**Streamlining the Project Approval for the Construction and Operation
of a Resource Recovery and Recycling Facility, file No. S03/03614**

Transpacific Refiners wish to amend and streamline the consent and licensing conditions on our site at 11 Kyle St, Rutherford.

Figure 1

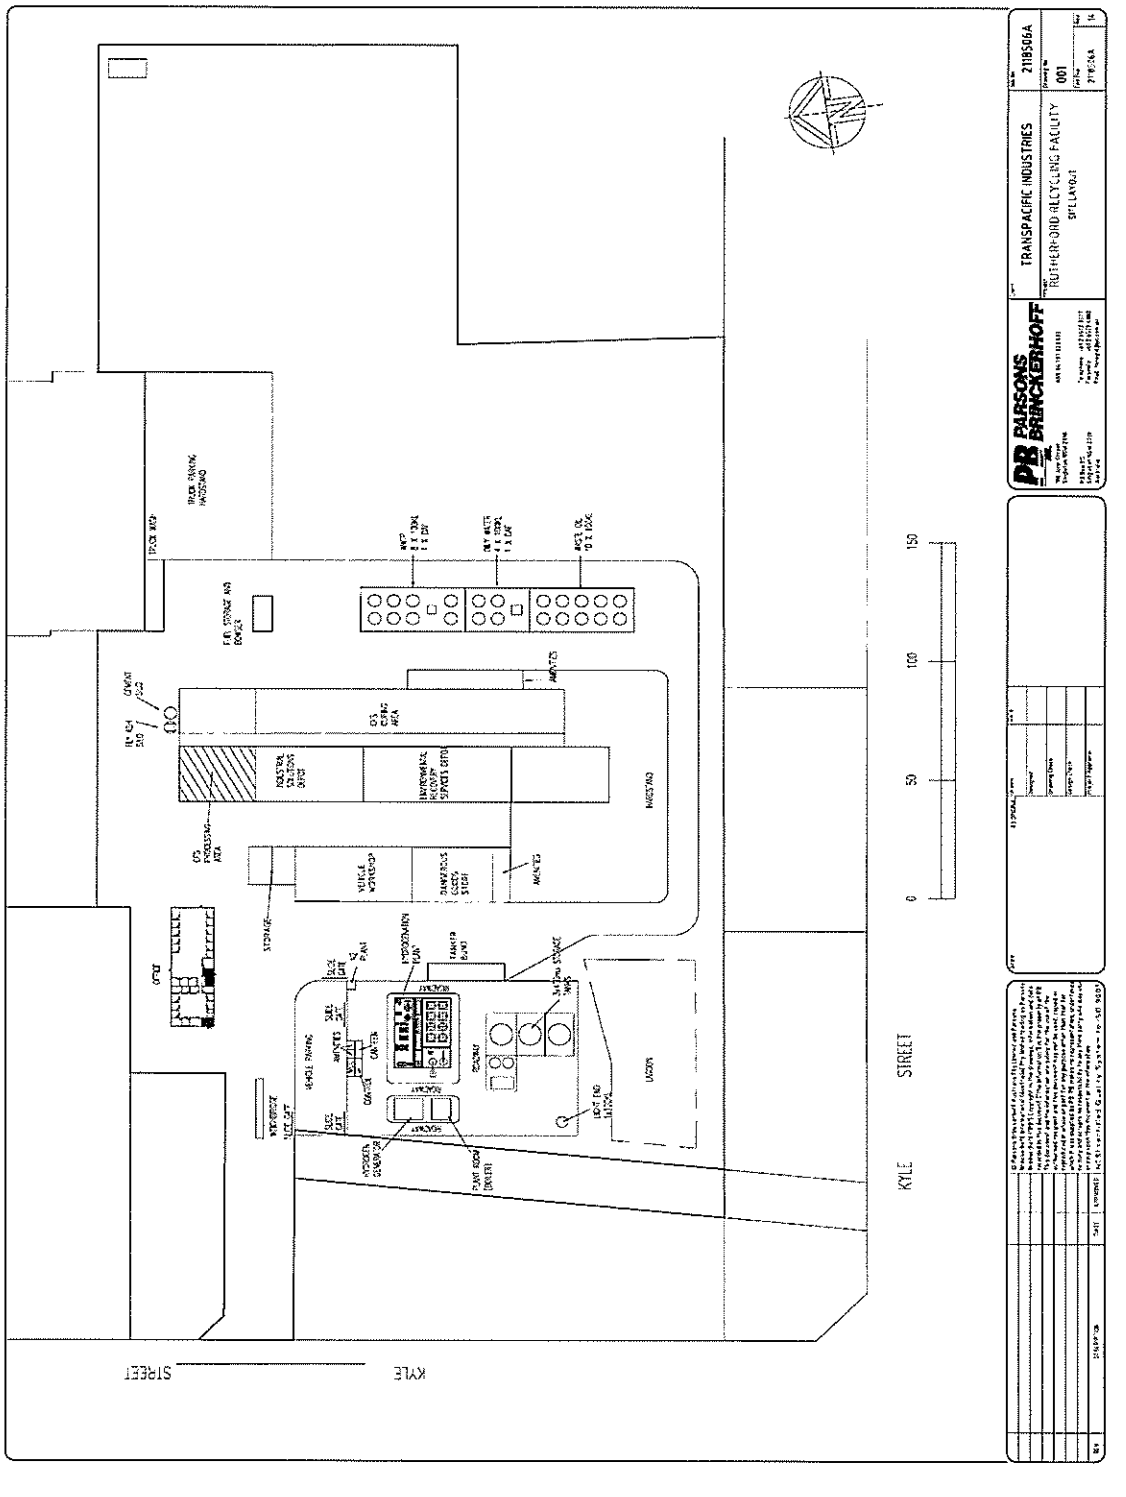
Figure one in Appendix A shows the original proposed location of these areas.

The industrial cleaning services depot is marked as Industrial Solutions Depot and was to house the truck wash, while the transport vehicle depot and environmental recovery services depot are marked as such.

Reference to these can now be removed, the area marked as Vehicle Workshop is now a general workshop for the refinery.

Historical Ground Water Data

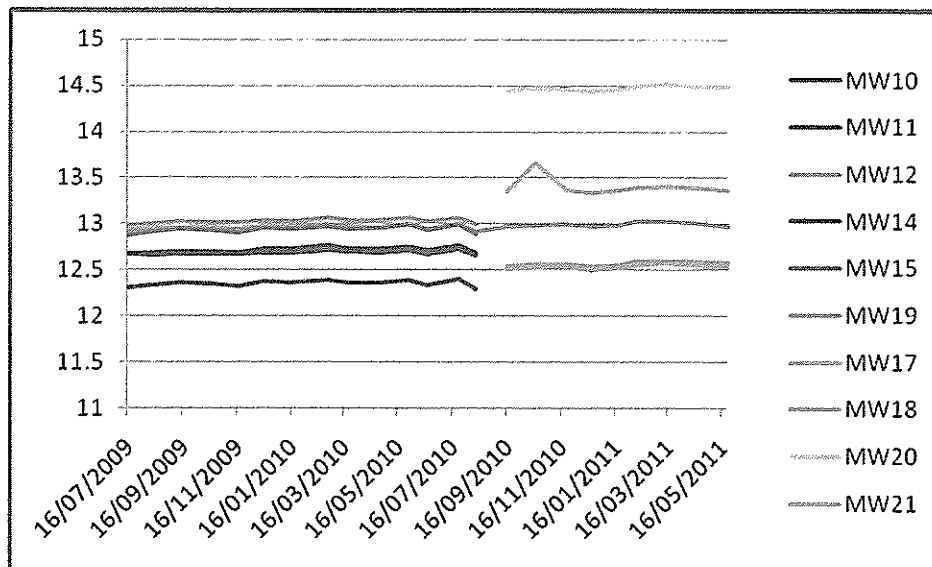
Monthly ground water dipping shows that there is no notable variation in Ground Water Levels. Note the bores being monitored changed in August 2010 as a result of a licence change with the OEH, the purpose of this was the focus the monitoring on the area known to be contaminated.

Ground Water levels are also recorded in the bi annual Ground Water report required as part of the EPL, thus we feel that ongoing monthly measurements are no longer required and wish to remove this requirement.
